ITB # 26-408 Hampstead Library Construction Services

Addendum 3

December 15, 2025

Pender County Library, Hampstead Branch

Landscape Plan

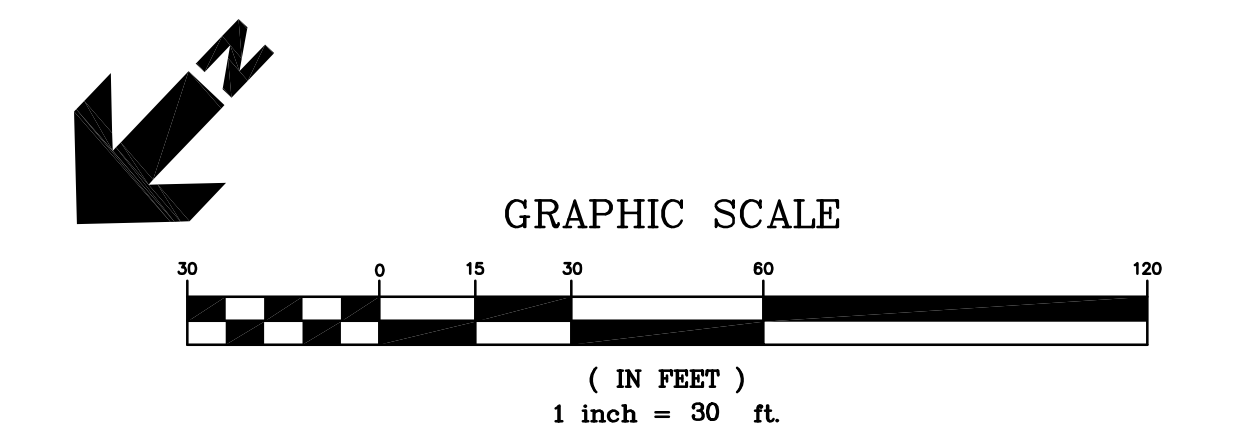
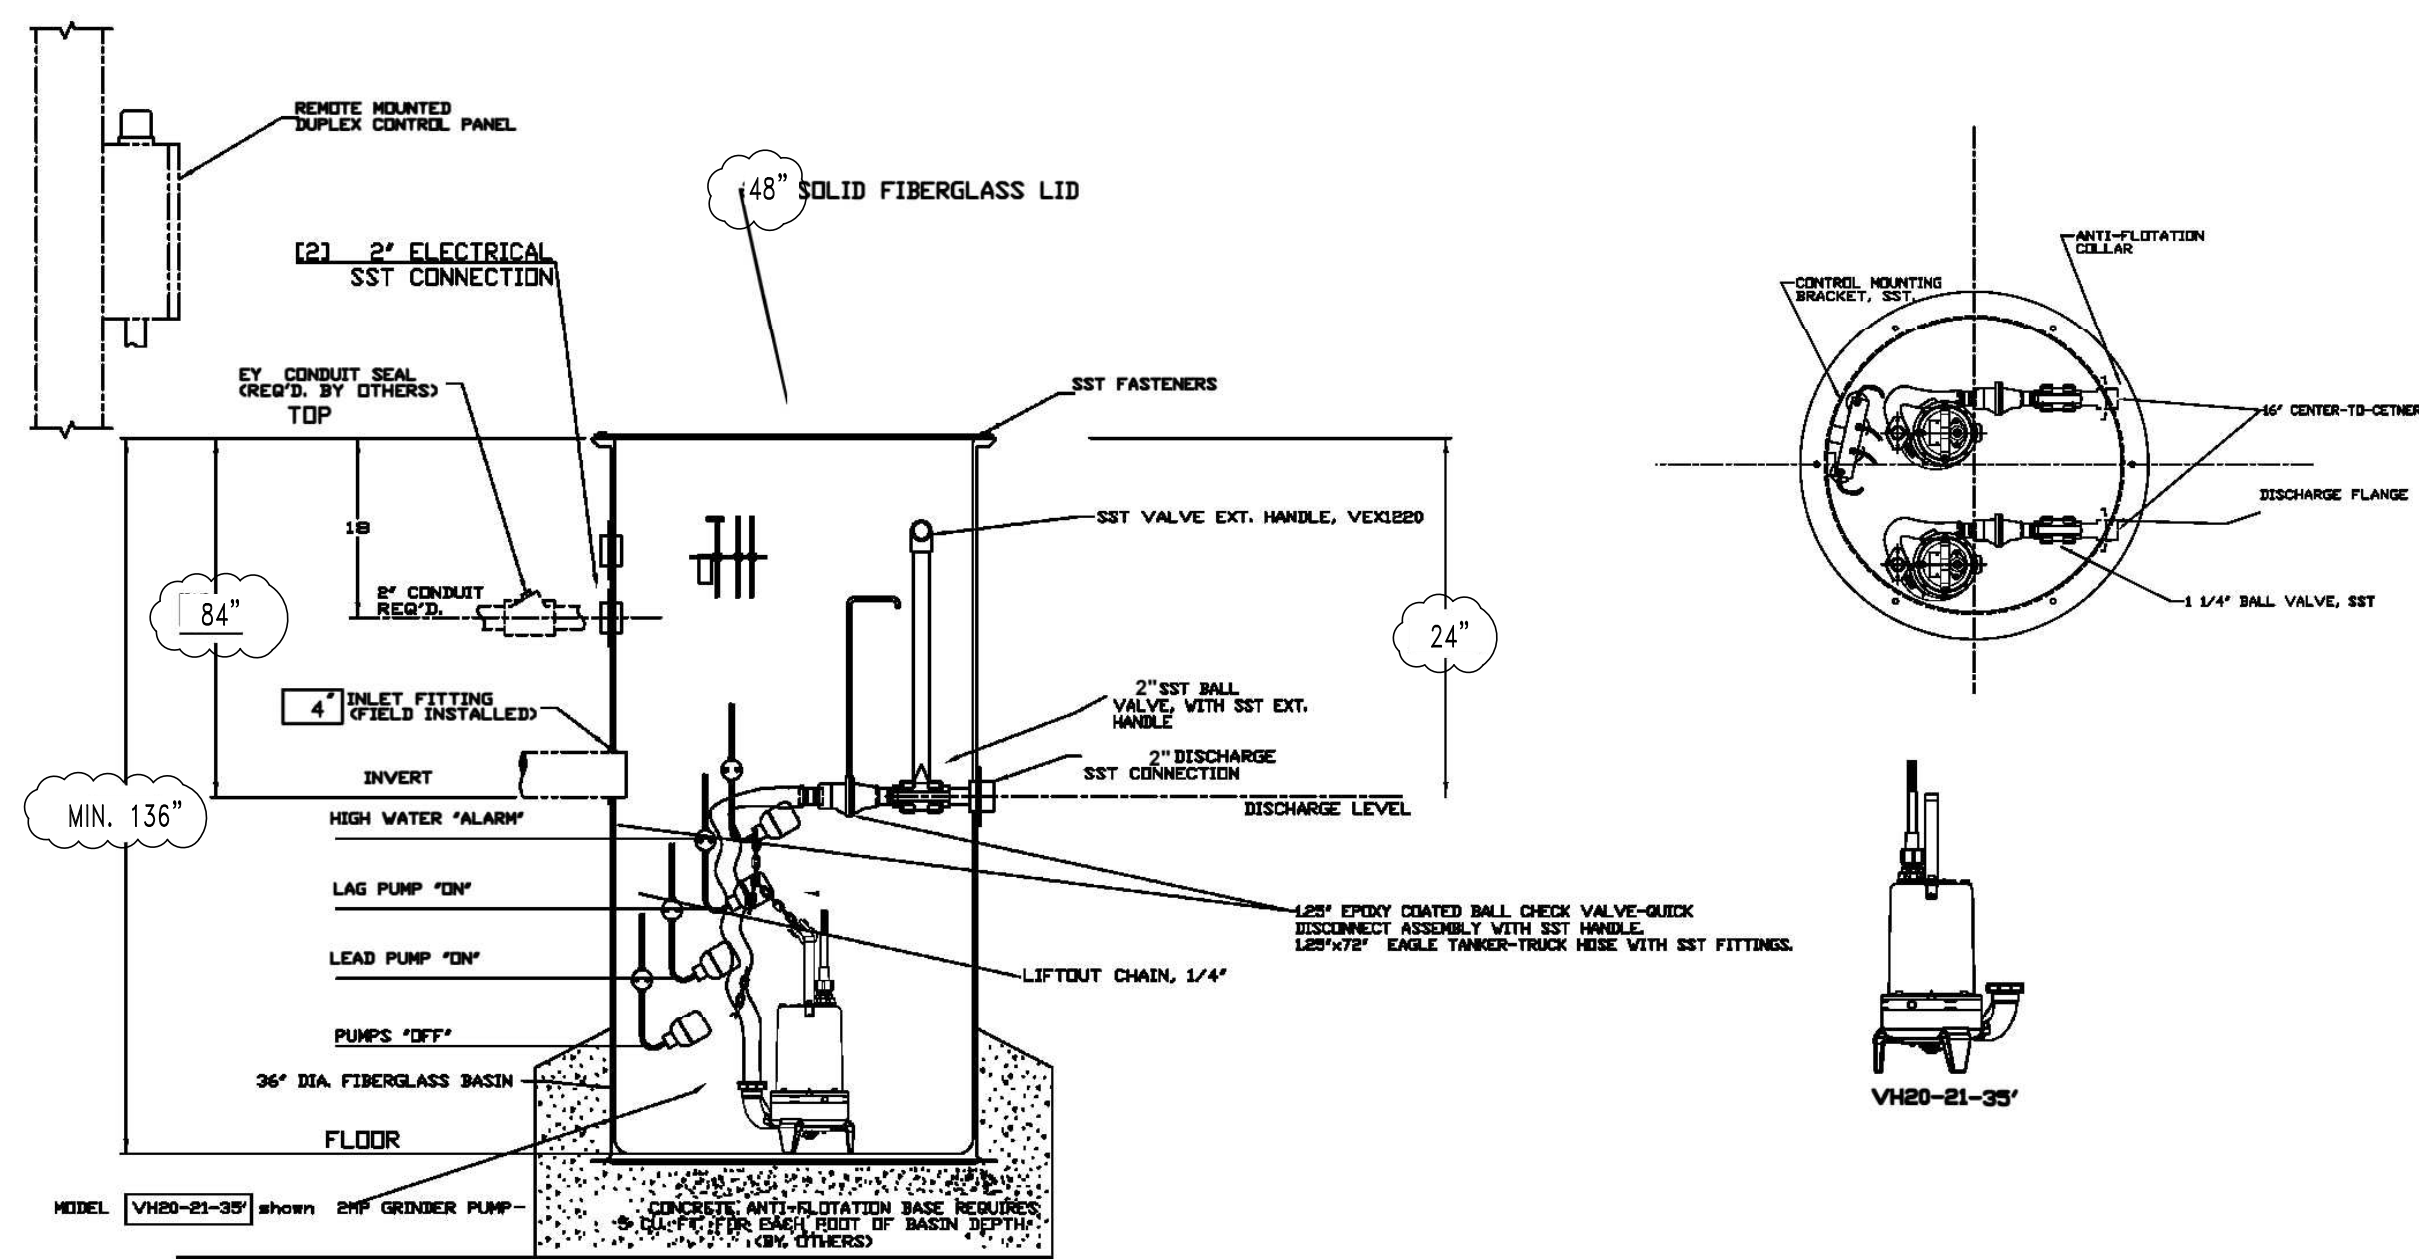
- 1. In the drawing index on sheets G1.0 and C0.0, please disregard reference to sheet C3.0. This sheet is not included in the drawing set and is not needed.
- 2. Sheet 5.0 Landscape Plan is replaced, see attached revised plan.
- 3. Sheet U5.1 Site Utility is replaced, see attached revised plan.
- 4. Sheet U9.5 Pluris Details 1 is replaced, see attached revised plan.
- 5. Sheet M3.0 Mechanical Control Diagrams, please add the following clarification:
 - a. Packaged Heat Pump Unit - Single Zone VAV & OA Economizer (PHP-1 & 6): Update sequence of operation A. Occupied 3. for Supply Air Fan **to adjust speed in stages to match compressor staging** to maintain space temperature setpoint.

Rev.	Date	Notes
1	12/9/25	TRC COMMENTS
